UNITED STATES DEPARTMENT OF COMMERCE United States Patent and Trademark Office Address: COMMISSIONER FOR PATENTS P.O. Box 1450 Alexandria, Virginia 22313-1450 www.uspto.gov

APPLICATION NO.	FILING DATE	FIRST NAMED INVENTOR	ATTORNEY DOCKET NO.	CONFIRMATION NO.	
10/806,487	03/23/2004	Greg Marik	31132.196	2793	
46333 HAVNES ANI	7590 04/12/2007 D BOONE, LLP		EXAMINER		
901 MAIN ST	o bootte, edi		MILLER, CHERYL L		
SUITE 3100 DALLAS, TX	75202		ART UNIT PAPER NUMBER 3738		
SHORTENED STATUTOR	RY PERIOD OF RESPONSE	MAIL DATE	DELIVERY MODE		
3 MC	NTHS	04/12/2007	PAPER

DETAILED ACTION

Attachment #1 (marked up)

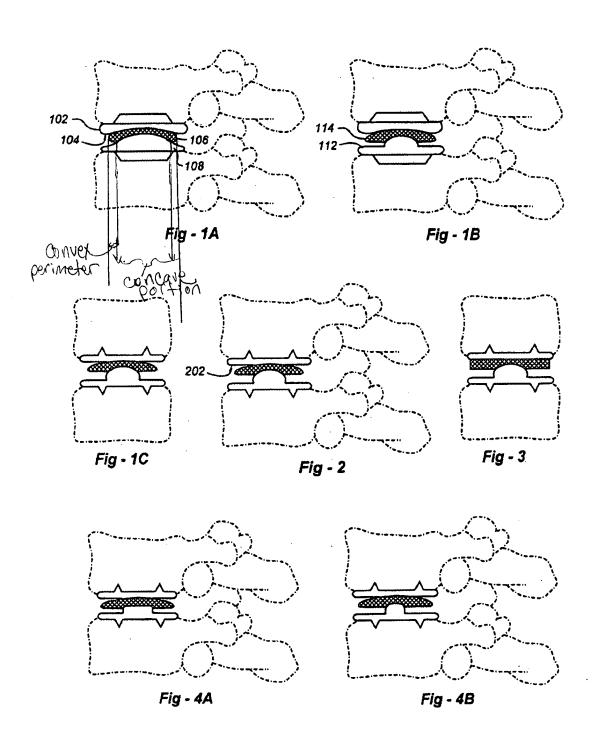
Claims 1-4, 9, 11, 15-18, 21-23, 27-29, and 32-37 are rejected under 35 U.S.C. 102(e) as being clearly anticipated by Ferree (US 7,048,764 B2, cited previously). Ferree discloses an implant (see fig.1a; attachment 1) comprising first member (102), second member (108) and center member (106). Ferree discloses the radius of curvature of the first member (102) to be larger than the radius of curvature of the second member (108; col.2, lines 59-67; col.3, lines 1-3). Ferree discloses the center member (106) to have curvatures that are similar to the curvatures of the first and second members (congruent; col.2, lines 64-66). Ferree's implant inherently translates, due to the structure is the same as the applicant's and therefore will function the same. Ferree discloses the curvatures to be constant (spherical; col.2, lines 66-67). Ferree discloses the first curvature to be concave and the second curvature to be convex (see figs.1a-1c). Ferree's implant is capable of being used as a shoulder, knee, or hip prosthesis (these claims are intended use language and Ferree's implant is capable of being placed in such a location). Ferree discloses the center member to have a third surface that is convex, and a fourth surface that is concave in the center portion and convex surrounding, see attachment 1.

Attachment #2 (marked up)

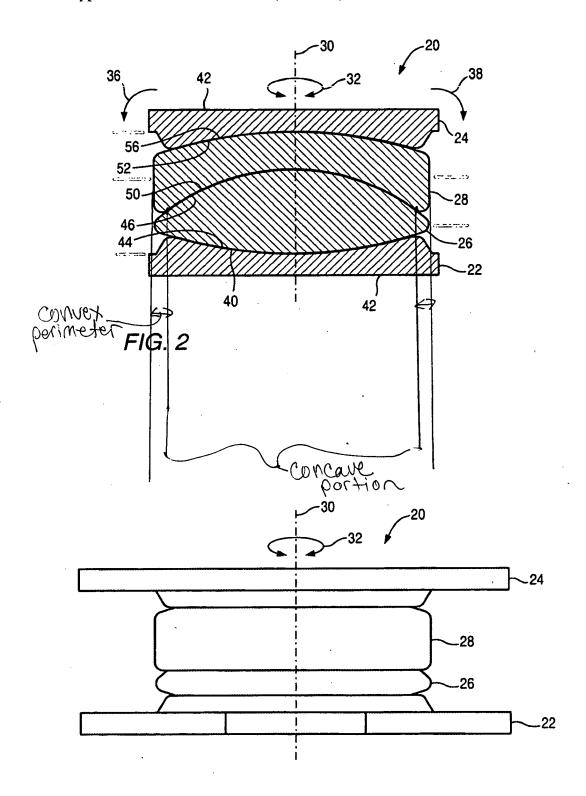
Claims 1, 9, 15-18, 21-23, 27-29, and 32-37 are rejected under 35 U.S.C. 102(e) as being anticipated by Marino et al. (US 2004/0133278 A1, cited previously). Marino discloses an implant (see fig.2) comprising first member (24), second member (22+26) and center member (28). Marino discloses the radius of curvature of the first member (24) to be larger than the radius of curvature of the second member (top surface of 26 seen as a smaller curvature than the

surface of 24). Marino discloses the center member (28) to have curvatures that are similar to the curvatures of the first and second members (seen in fig.2 as congruent). Marino's implant translates (P0042, P0045). Marino discloses the first curvature (56) to be concave and the second curvature (46) to be convex (see fig.2). Marino's implant is capable of being used as a shoulder, knee, or hip prosthesis (these claims are intended use language and Marino's implant is capable of being placed in such a location). Marino discloses the center member (28) to have a third surface (52) that is convex, and a fourth surface (50) that is concave in the center portion and convex surrounding, see attachment 2.
